**SUBJECT:** **Nine Mile Point Nuclear Station, Units 1 and 2**  
Renewed Facility Operating License Nos. DPR-63 and NPF-69  
Docket Nos. 50-220 and 50-410

Response to Request for Additional Information Re: Overall Integrated Plan for  
Reliable Spent Fuel Pool Instrumentation (Order EA-12-051) (TAC Nos.  
MF1131 and MF1132)

**RESPONSE TO REQUEST FOR ADDITIONAL INFORMATION**

Figure 1

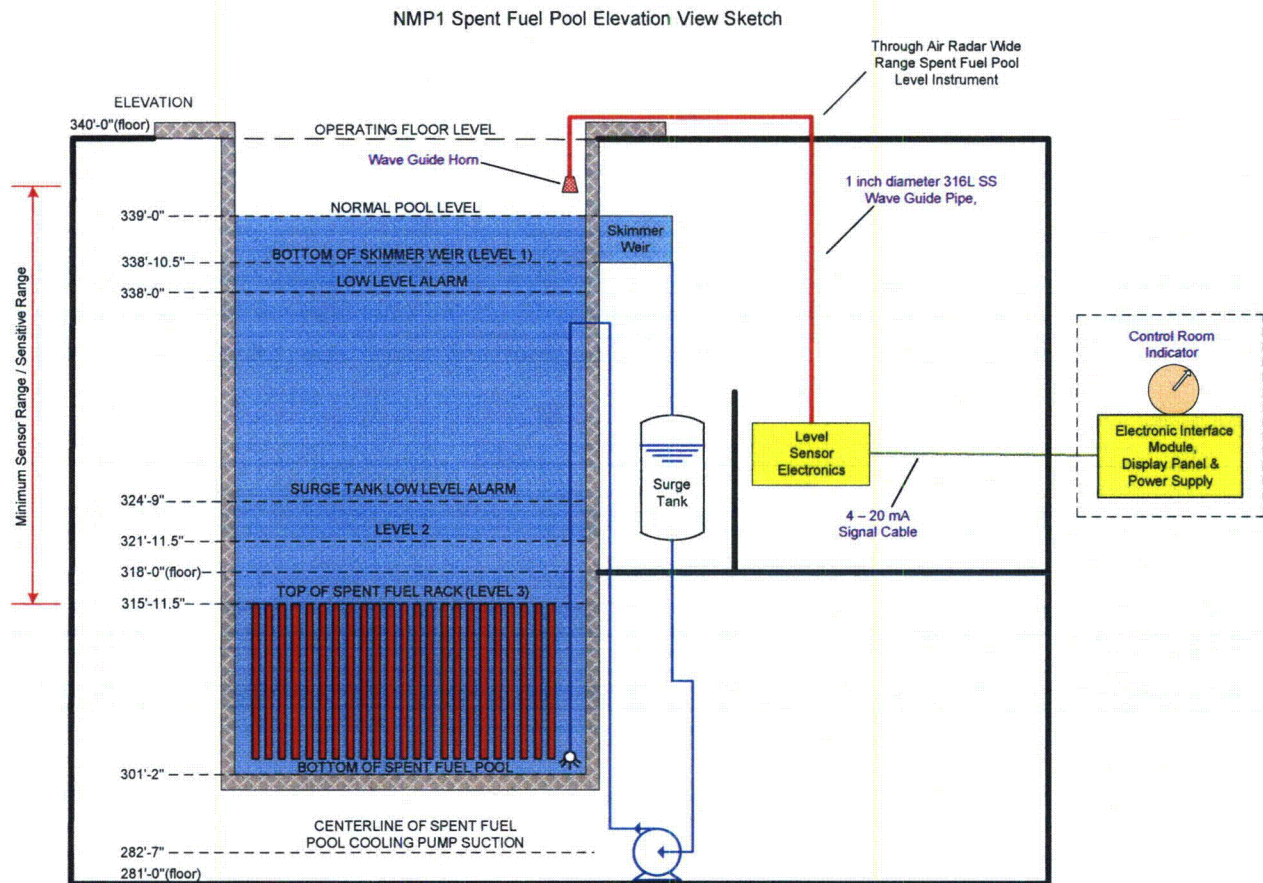
- a) For Level 1, specify how the identified location represents the HIGHER of the two points described in the NEI 12-02 guidance for this level.*
- b) A clearly labeled sketch depicting the elevation view of the proposed typical mounting arrangement for the portions of instrument channel consisting of permanent measurement channel equipment (e.g., fixed level sensors and/or stilling wells, and mounting brackets). Indicate on this sketch the datum values representing Level 1, Level 2, and Level 3, as well as the top of the fuel. Indicate on this sketch the portion of the level sensor measurement range that is sensitive to measurement of the fuel pool level, with respect to the Level 1, Level 2, and Level 3 datum points.*

- b) The instrument chosen for both primary and backup channels is the AREVA VEGAPULS 62ER Through Air Radar manufactured by VEGA Americas, Inc. Each channel will be mounted at the SFP edge and comprised of a horn antenna, waveguide assembly and mounting bracket, electronic sensor, and a display panel. The radar horn antenna is positioned above the SFP water surface and is capable of measuring from the mounting location on the SFP curb to the top of the fuel racks. Figure 1 shows an elevation view sketch of the instrumentation arrangement for NMP1. The sketch shows the datum values of Levels 1, 2, and 3, and the top of the Spent Fuel Racks as previously described in the submitted Overall Integrated Plan. The Through Air Radar sensor measurement range, labeled "Minimum Sensor Range / Sensitive Range" in Figure 1, encompasses the Level 1, Level 2, and Level 3 datum points.

Figure 2

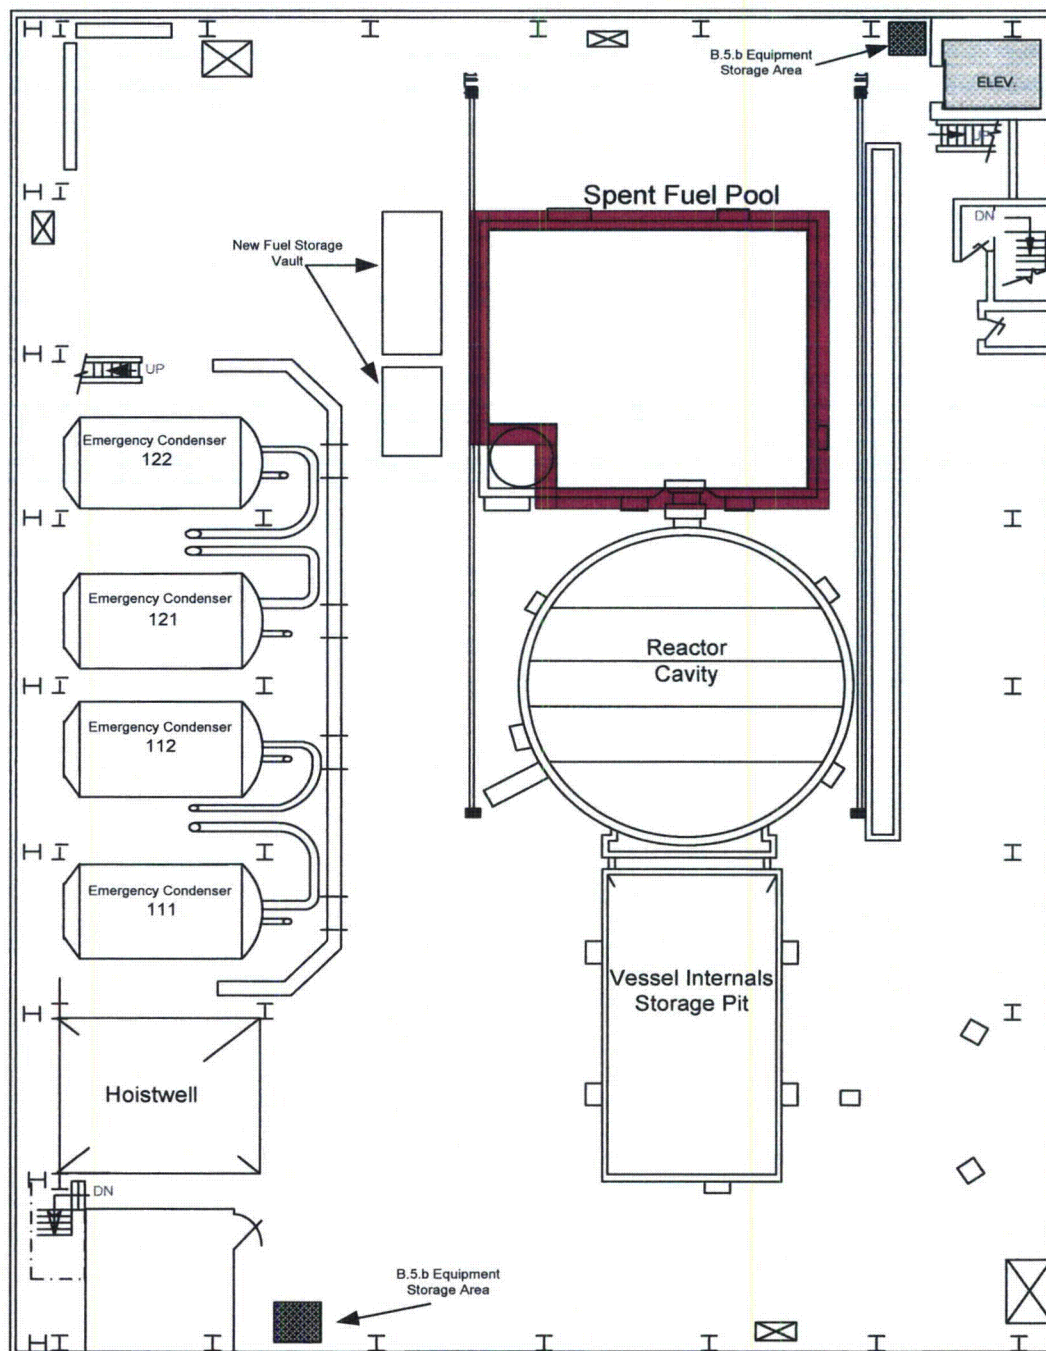
- c) Detailed information regarding the analysis used to determine Level 2 including assumptions for amount and location of source material, assumptions regarding future changes to amount of source material and locations that are valid for the stated 100 mrem/hr dose rate appropriately marked on the floor plan. Include a discussion regarding dose rates for stored spent fuel versus that of other material that may be stored in the pool.*

Based on the calculation performed, with 6 feet of water over the SFP racks, Figure 2 depicts the projected dose rate locations on a plan view sketch, from the edge of the SFP up to 2 foot back from the SFP edge, and up to 6 foot high. All areas surrounding the SFP under this condition are calculated to be less than 100 milli-Rem/hour (mRem/hr).

Figure 5

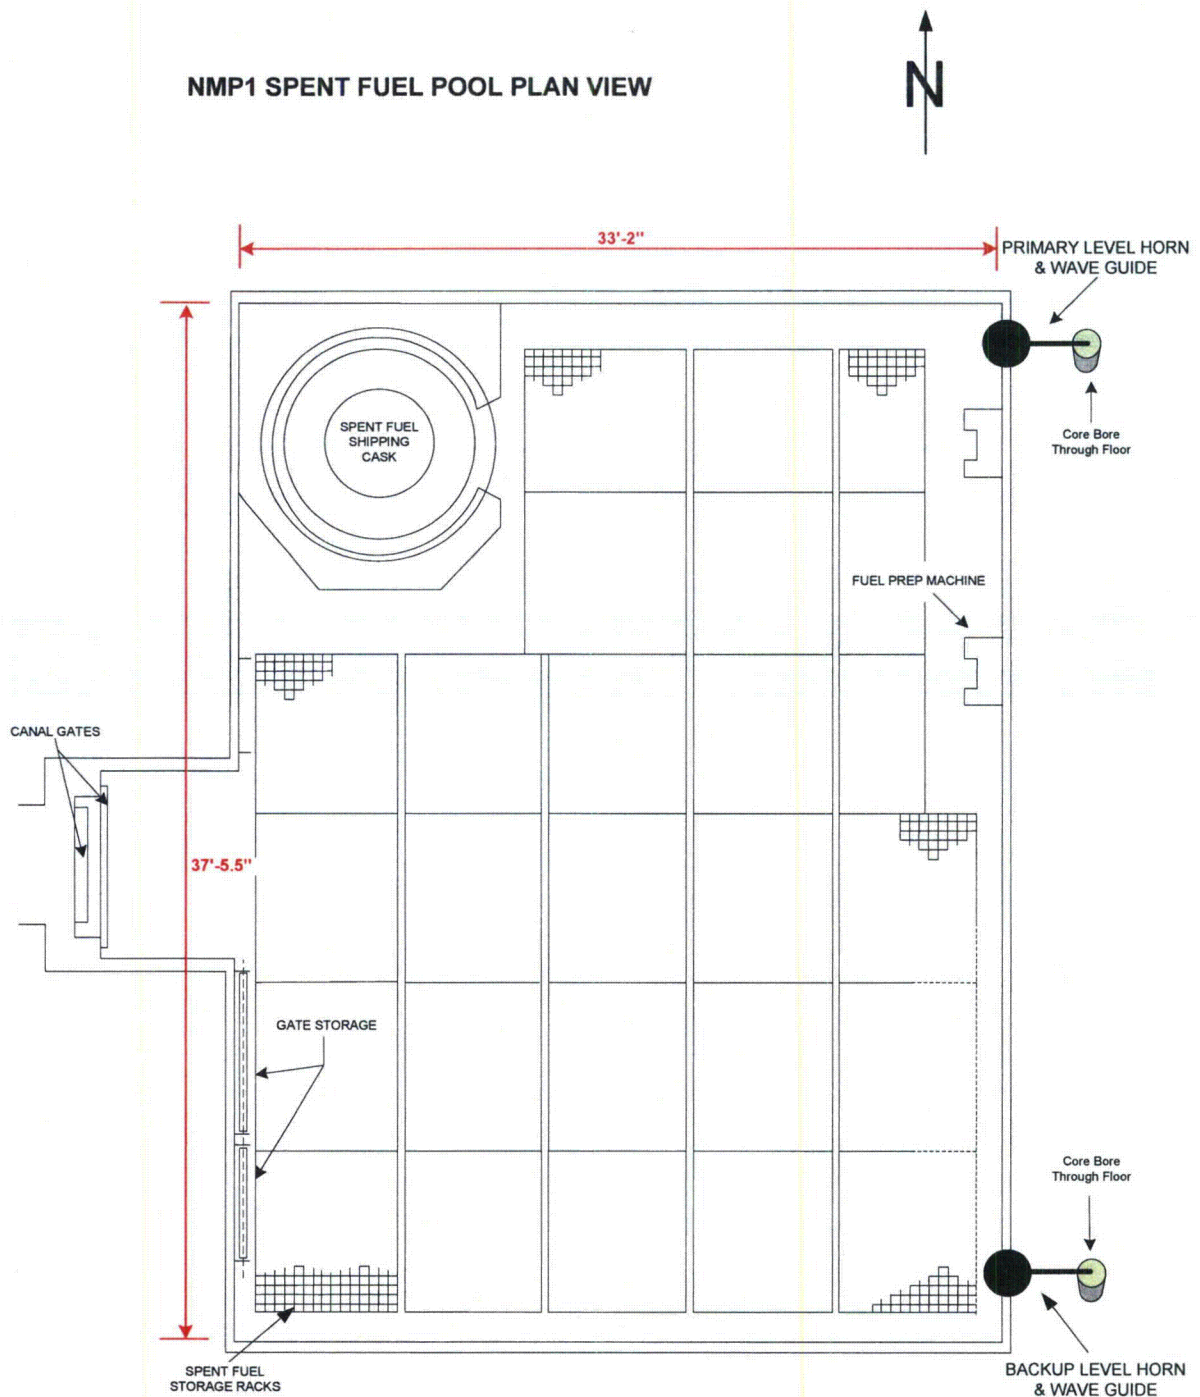
*Please provide, for both units, a clearly labeled sketch or marked-up plant drawing of the plan view of the SFP area, depicting the SFP inside dimensions, the planned locations/placement of the primary and back-up SFP level sensor, and the proposed routing of the cables that will extend from the sensors toward the location of the read-out/display device.*

Figure 5 is a plan view sketch of the NMP1 SFP with the inside dimensions indicated. The new wide range level instrumentation channel configuration desired placement layout is also shown on Figure 5 for the Primary and Backup channels. They will be mounted at the SFP edge as shown and be comprised of a horn antenna and waveguide assembly which is routed to the sensor on the 318' elevation below through a floor core bored hole. The proposed routing of the cables that will extend from the sensors toward the location of the read-out/display device has not been determined.

Figure 7

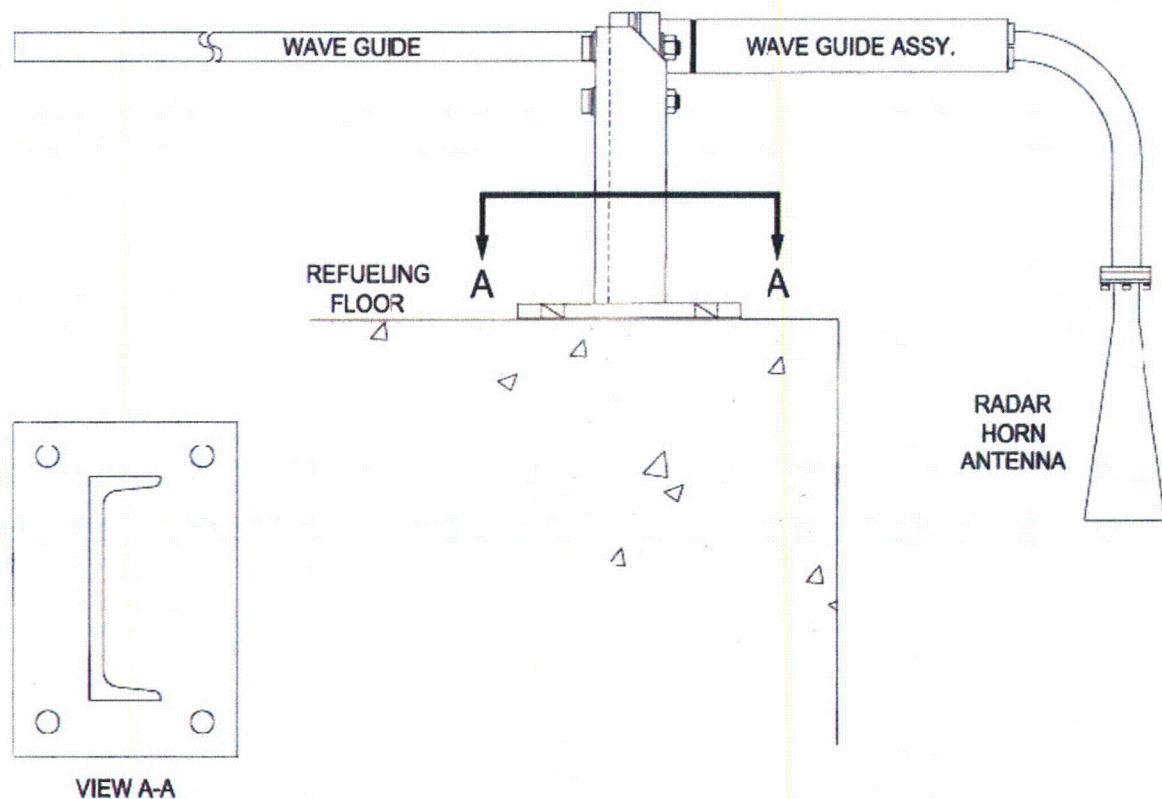
- b) A description of the manner in which the level sensor (and stilling well, if appropriate) will be attached to the refueling floor and/or other support structures for each planned point of attachment of the probe assembly. Indicate in a schematic the portions of the level sensor that will serve as points of attachment for mechanical/mounting or electrical connections.*

- b) The Through Air Radar waveguide horn and waveguide piping assembly is attached to a waveguide assembly mounting bracket. Figure 7 provides a visual representation of the SFP edge mounting configuration. There is no portion of the Through Air Radar level equipment that contacts the SFP water, nor is there any connection to the SFP liner. The horn antenna is cantilevered over the edge of the SFP and firmly fixed in a direction perpendicular to the SFP water surface. The bracket provides the attachment point for the horn and waveguide assembly to the refueling floor. Four bolts at the base of the bracket fasten the bracket to the refueling floor. For mounting to a concrete floor, the bolts may be anchor bolts in a range of sizes from 3/8 inch to 3/4 inch. The distance of the two nearest

Figure 8

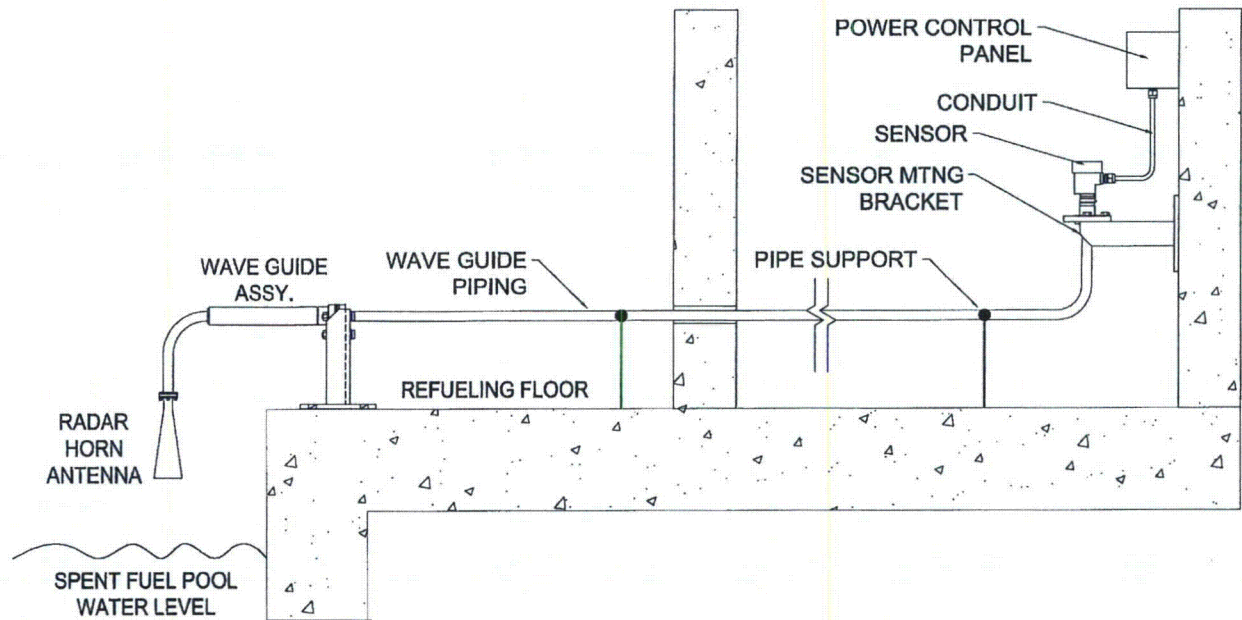
- c) A description of the manner by which the mechanical connections will attach the level instrument to permanent SFP structures so as to support the level sensor assembly.*

- c) Figure 8 provides a *standard* conceptual arrangement of the elements of the Through Air Radar system. The waveguide piping that is connected between the waveguide assembly at the SFP edge and the remotely located sensor will be attached to building structures using the applicable site design standards for seismic small bore pipe and supports in accordance with the design change process.
